ADA Curb Ramp New Construction Inspection Form (Parallel)

NW Main

23885.56

NW Lenox

PARALLEL RAMP (PL)

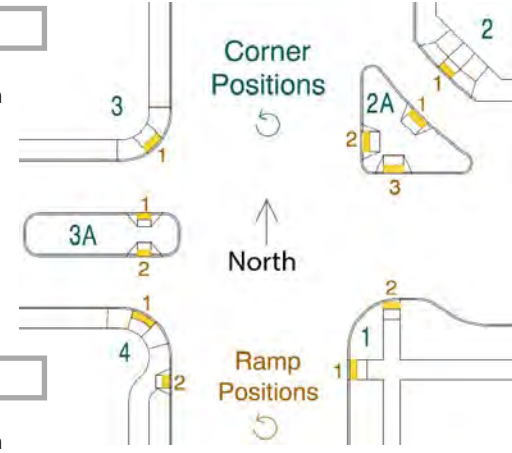
5.3 $\leq *$ ☐ $> *$ ☒

6.9 $\leq |5.0\%|$ ☒ $> |5.0\%|$ ☐

11.1 $\leq 8.3\%$ ☐ $> 8.3\%$ ☒

DWS IITD Fails RR 1
